SERVICE PROCEDURE

G-07514
February 2008

SUBJECT: SAFETY RECALL (U.S.)
BATTERY CABLES on certain MXT Models built
5/20/2006 thru 4/23/2007

Figure 1.

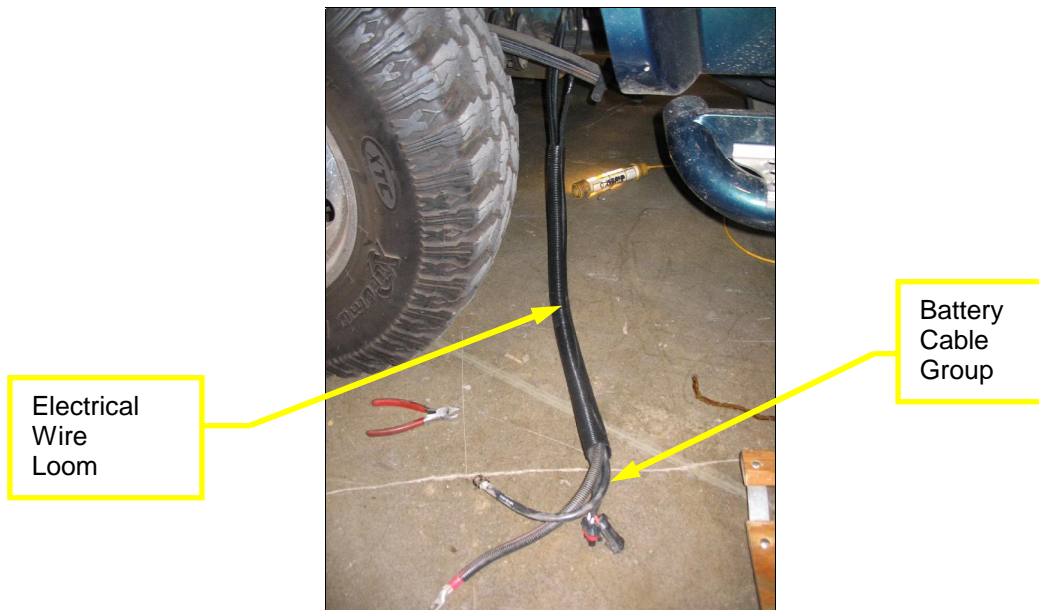
6. Install the electrical wire loom 2644081R1 over the battery cable group as shown in Figure 1.

Figure 2.

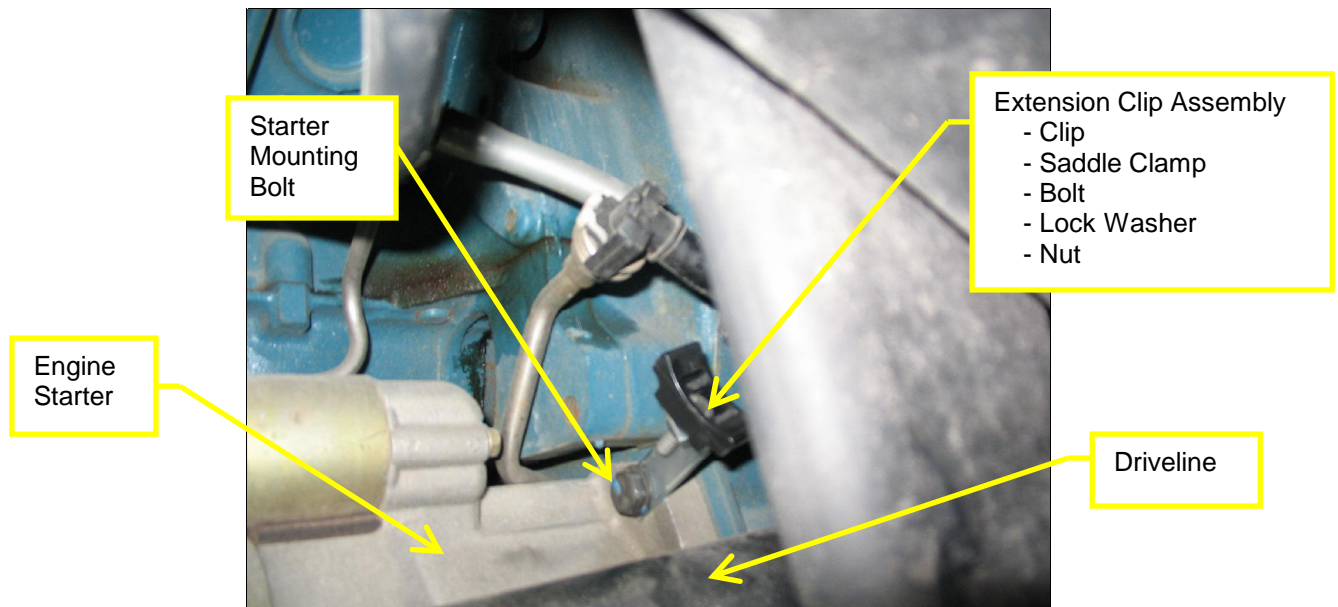
7. Install extension clip assembly onto the engine starter using the existing starter mounting bolt as shown in Figure 2. The parts needed are: 308578C1 extension clip, 2041341C1 saddle clamp, 25483R1 bolt, 120380 lock washer, and 25519R1 nut.

Figure 3.

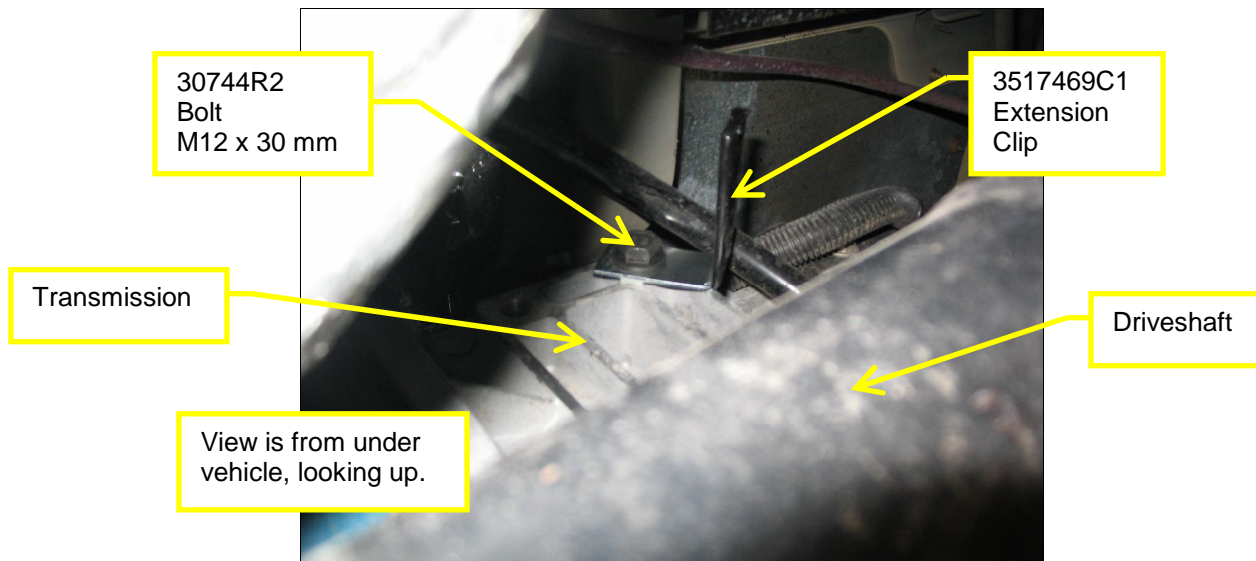
8. Install extension clip assembly onto the upper transmission mounting pad as shown in Figure 3. The parts needed are 3517469C1 extension clip and 30744R2 bolt.

Figure 4.

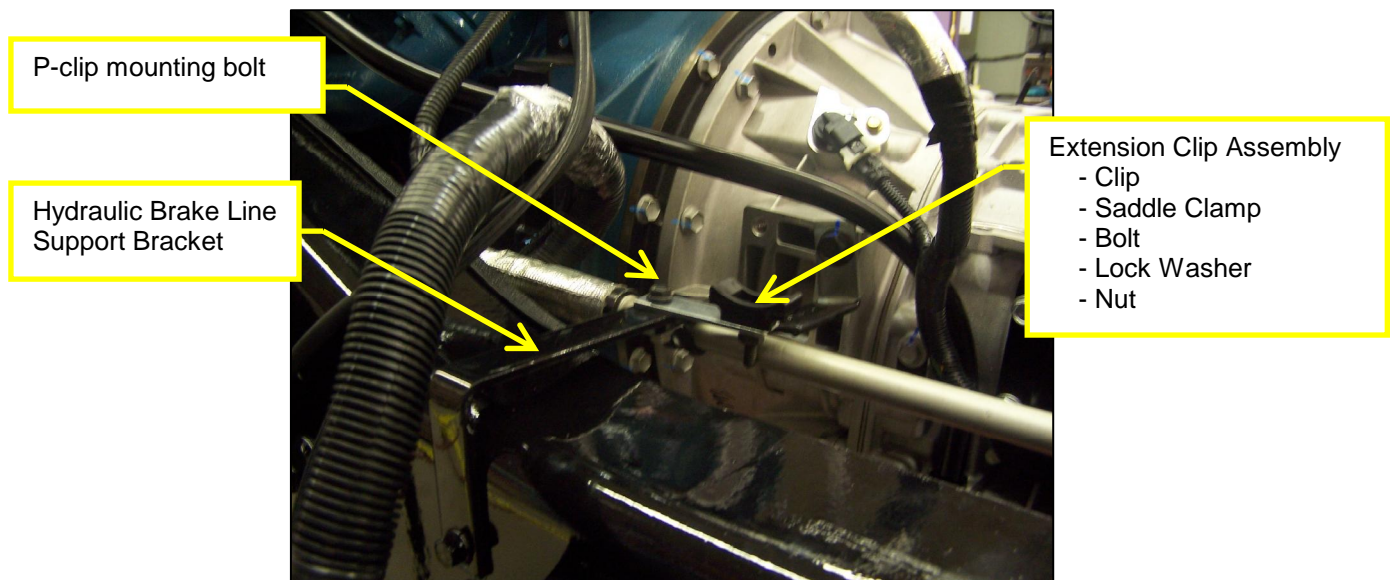
9. Install extension clip assembly onto the hydraulic brake line support bracket using existing p-clip mounting bolt as shown in Figure 4. The parts needed are: 432013C1 extension clip, 2041341C1 saddle clamp, 25483R1 bolt, 120380 lock washer, and 25519R1 nut.

Figure 5.

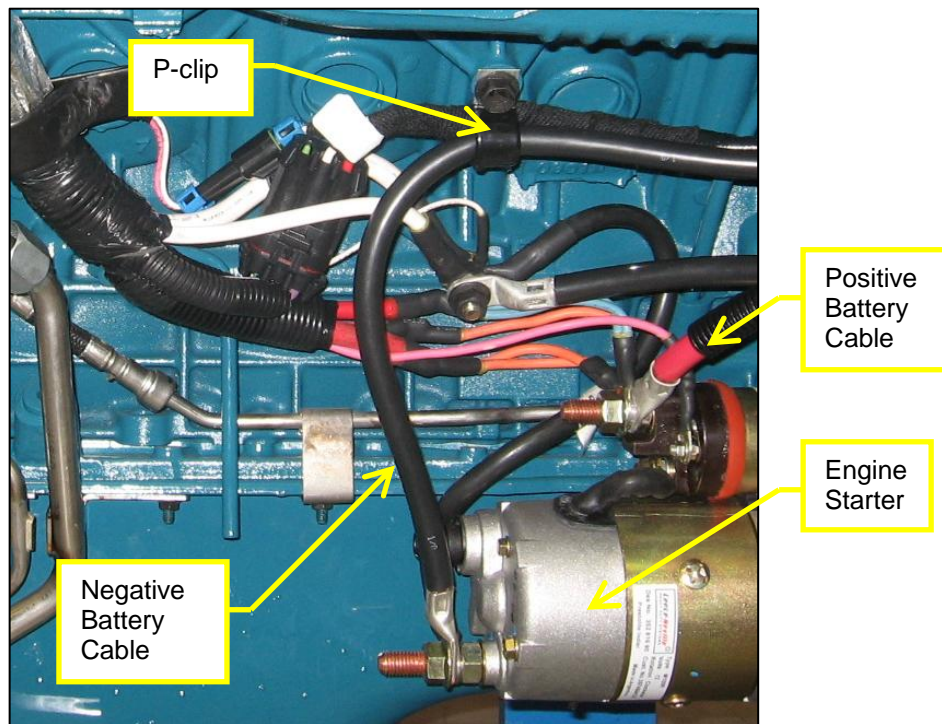
10. Route the negative battery cable thru the p-clip on the side of the engine as shown in Figure 5.

Figure 6.

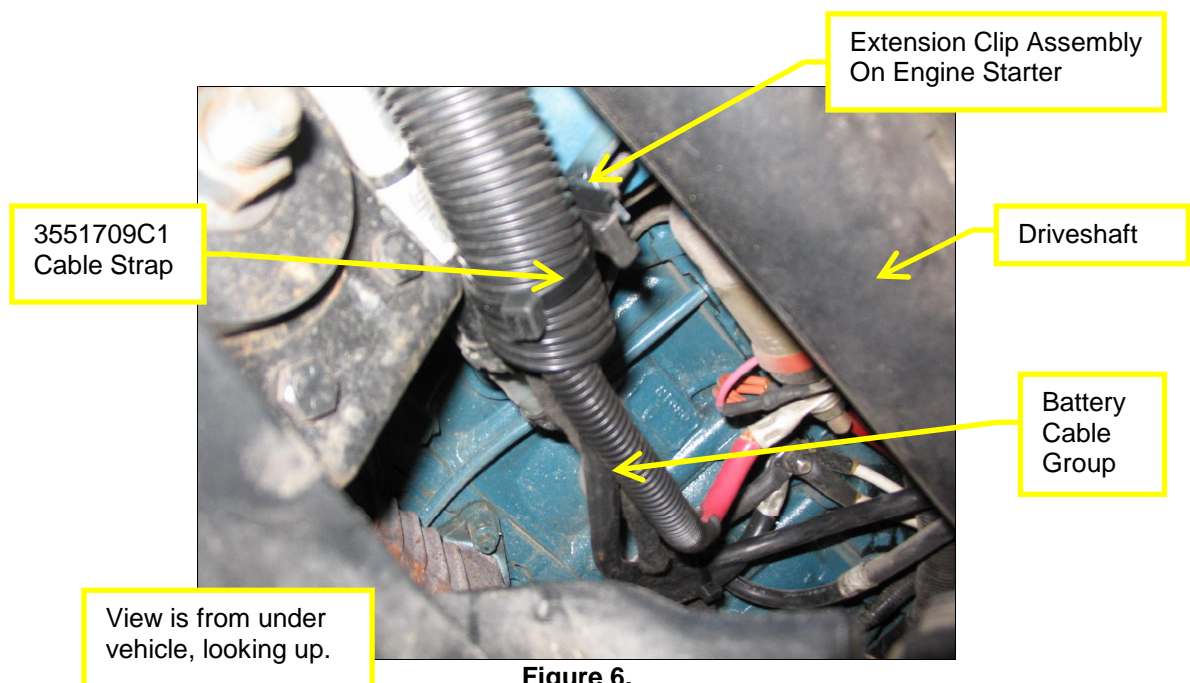
11. Route the positive cable, negative cable, and clean power to ground cable together at the extension clip assembly installed on the engine starter using 3551709C1 cable strap as shown in Figure 6.

Figure 7.

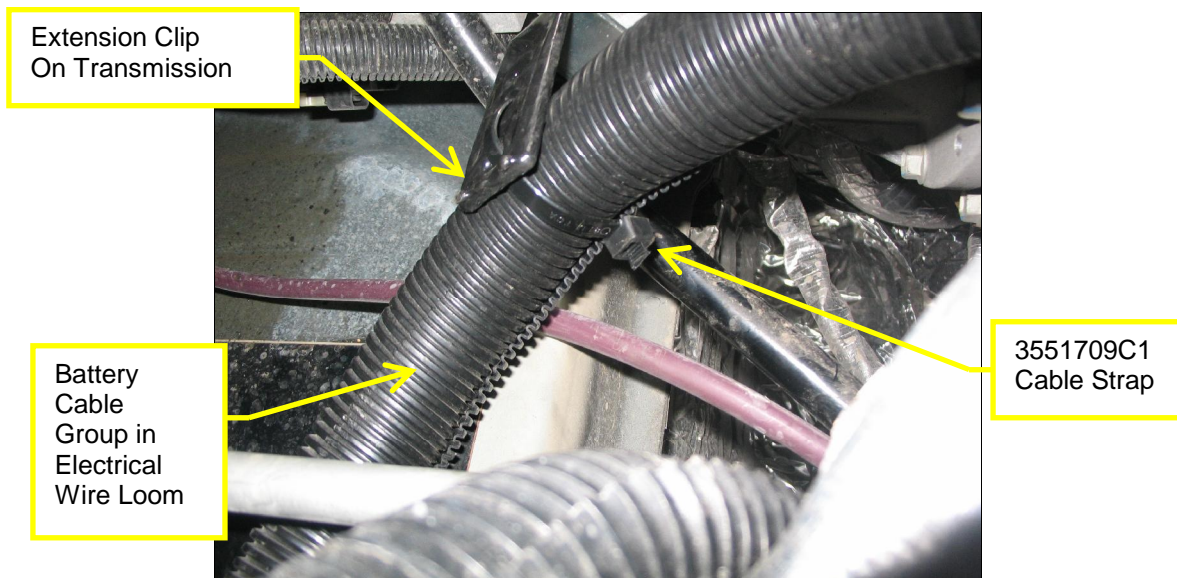
12. Route the battery cable group to the battery box using the newly installed extension clip assemblies as shown in Figures 7, 8, and 9. The parts needed are tie straps 3551709C1 and 3516934C1.
